## SECTION 00 91 13.1 – ADDENDUM 1

- A. Project Name: Hendricks County Coroner Office.
- B. Owner: Hendricks County Board of Commissioners.
- C. Architect: arcDESIGN, PC.
- D. Architect Project Number: 23158.
- E. Date of Addendum: December 8, 2023 .

## HENDRICKS COUNTY CORONER RELOCATION

**1A CEILING TYPES**  
1/12" = 1'-0"

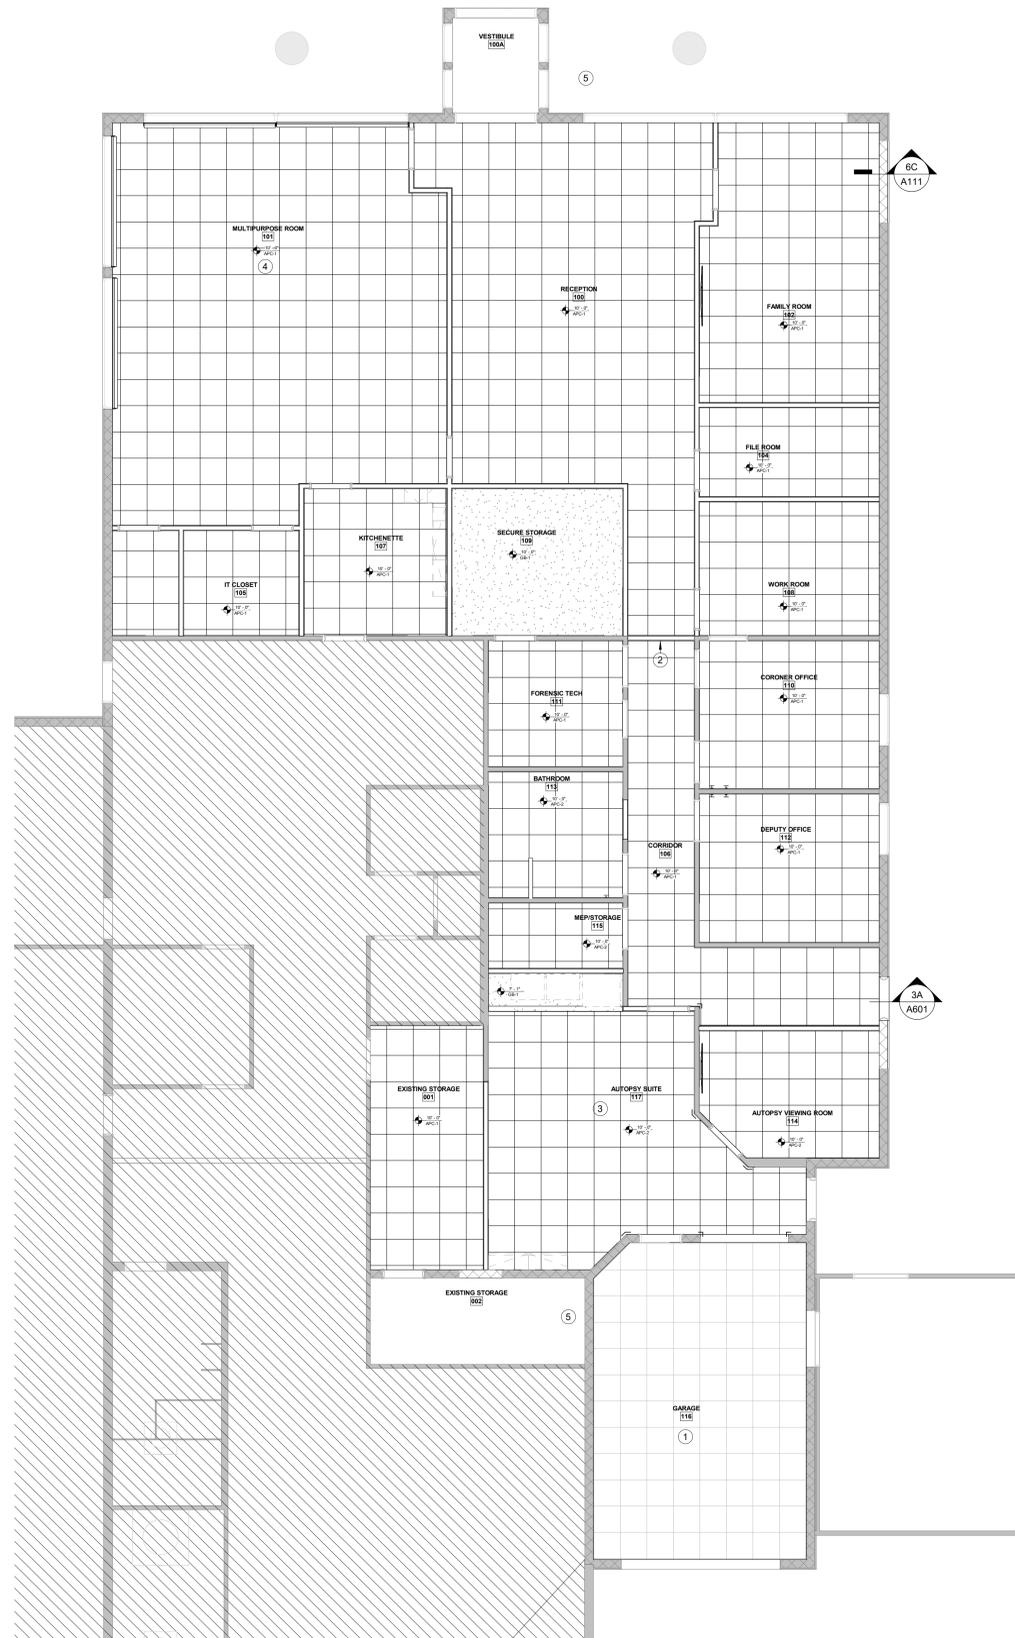
- A. Sheet A131 - REFLECTED CEILING PLANS (reissued).
  - 1. Drawing 1A CEILING TYPES : ADDED APC-2.

MECHANICAL PLAN  
3/16" = 1'-0"

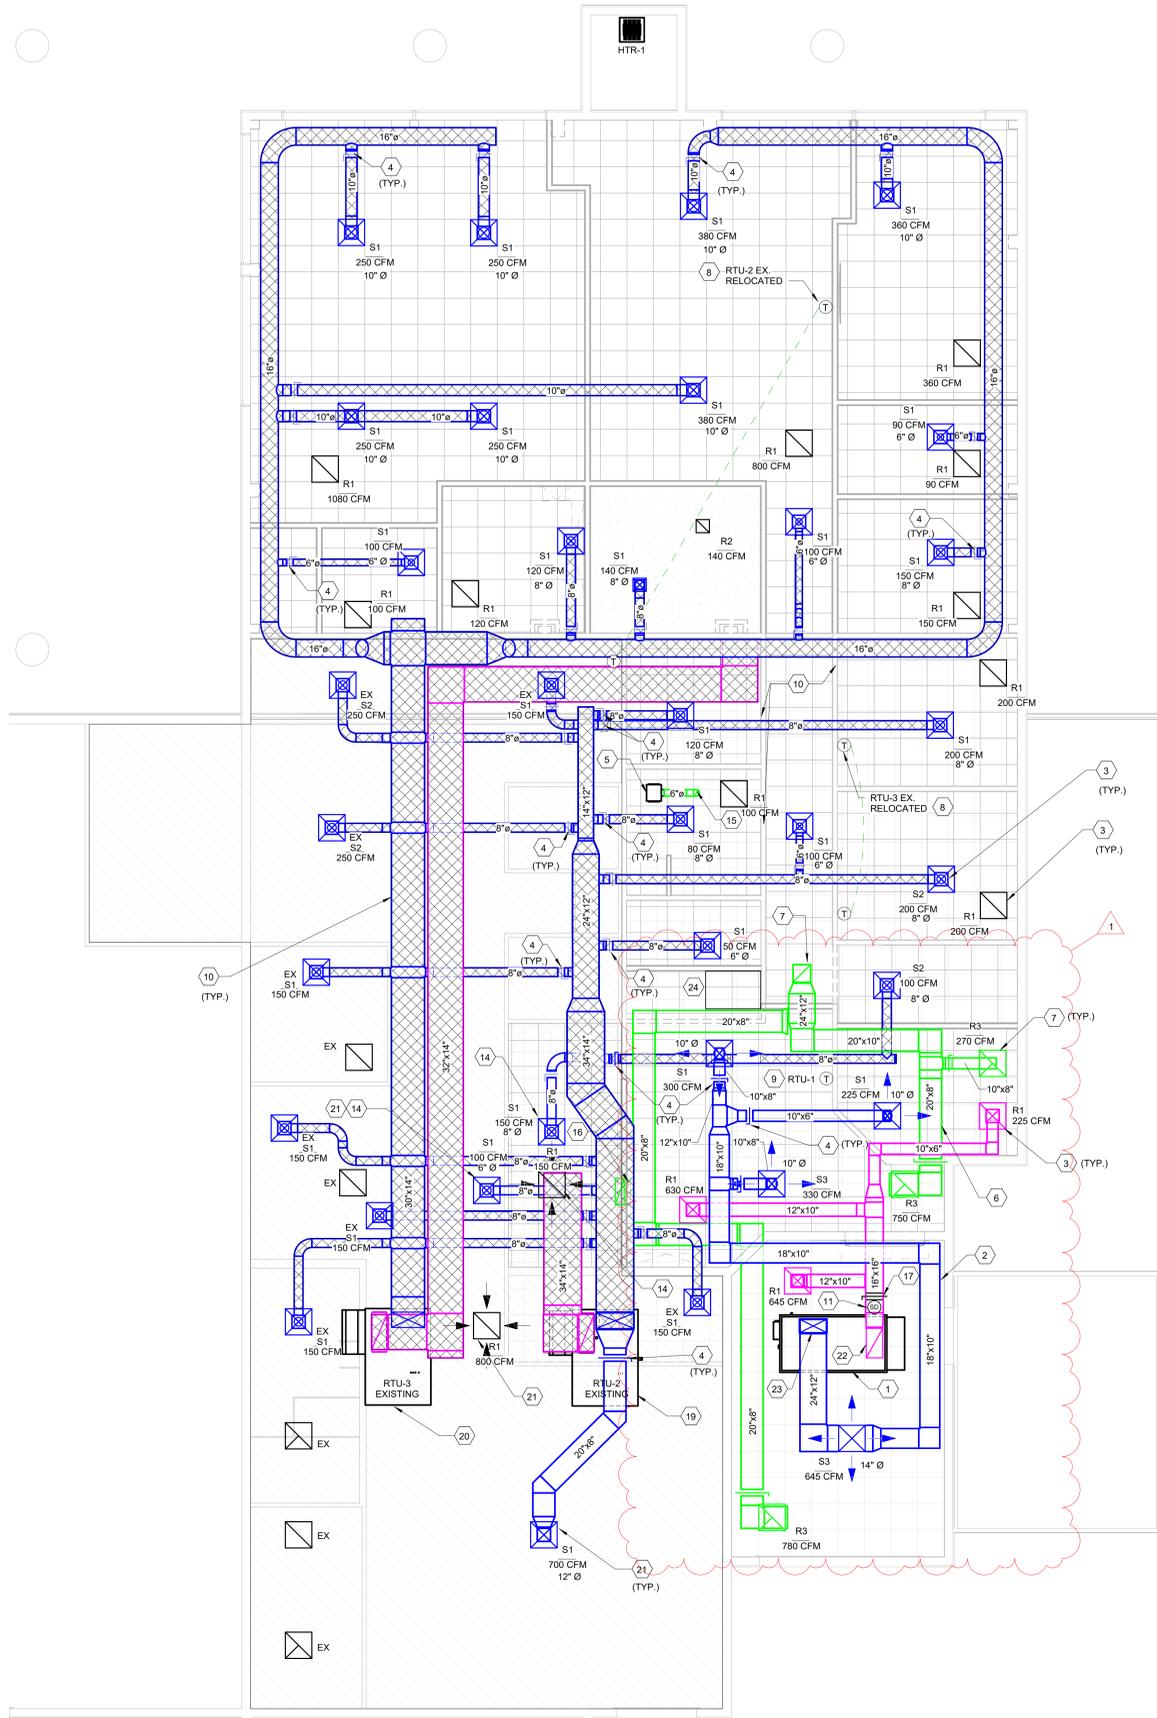
- C. Sheet M101 - MECHANICAL PLAN (reissued).
  - 1. Drawing MECHANICAL PLAN : Revised CFM callout in Autopsy Suite from 150 CFM, to 750 CFM. Associated components were already sized appropriately for 750 CFM.
